# Network Camera Firmware Version: V5.8.1 Release Note

Firmware			
Basic Information	Firmware Version:	V5.8.1 build 231017

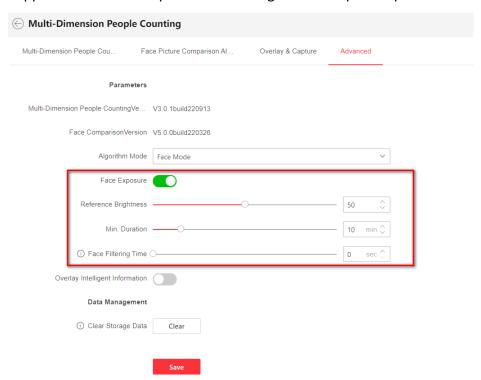
Dynamic Deduplication → Filtering Time Interval support in days, minutes, and seconds. Range from 0 day 0 hour 0 min 0 sec to 6 days 23 hours 59 min 59 sec.

• Support enable Face Exposure and configure face exposure parameters.
